MEMORANDUM

Project 23146 – Medford Zoning Updates

Subject Planning and Permitting Committee Meeting 2

Existing Uses

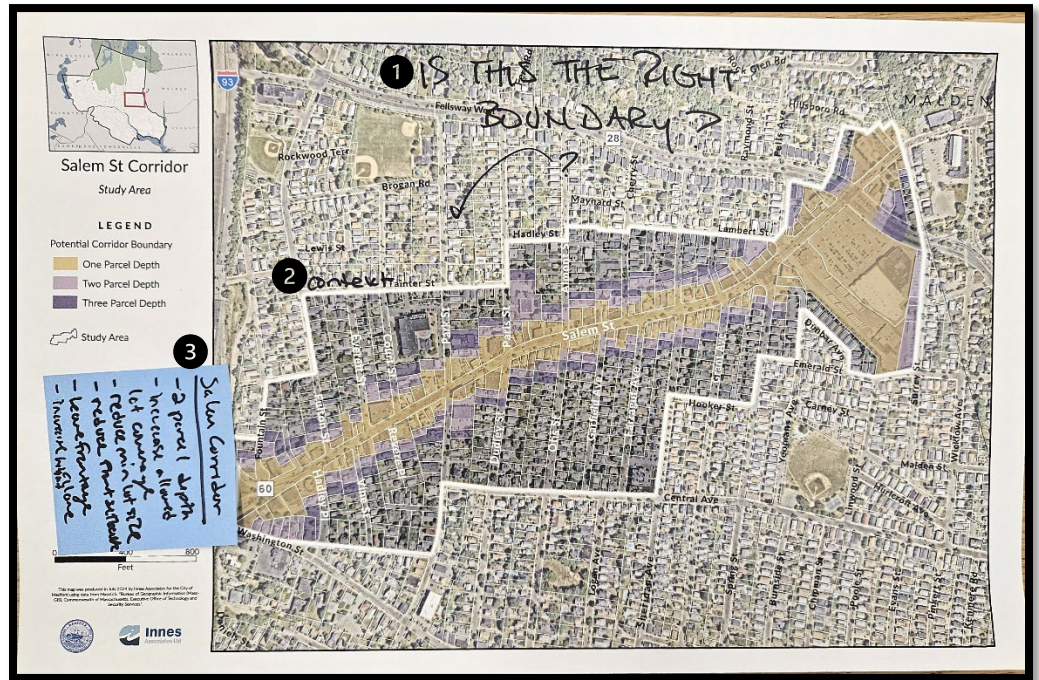
1. Would like more clarity on why some lots are commercial, others industrial, others mixed use. Can we streamline?
2. Possible to disincentivize flipping rentals → luxury condos via upzoning. SF2→APT?
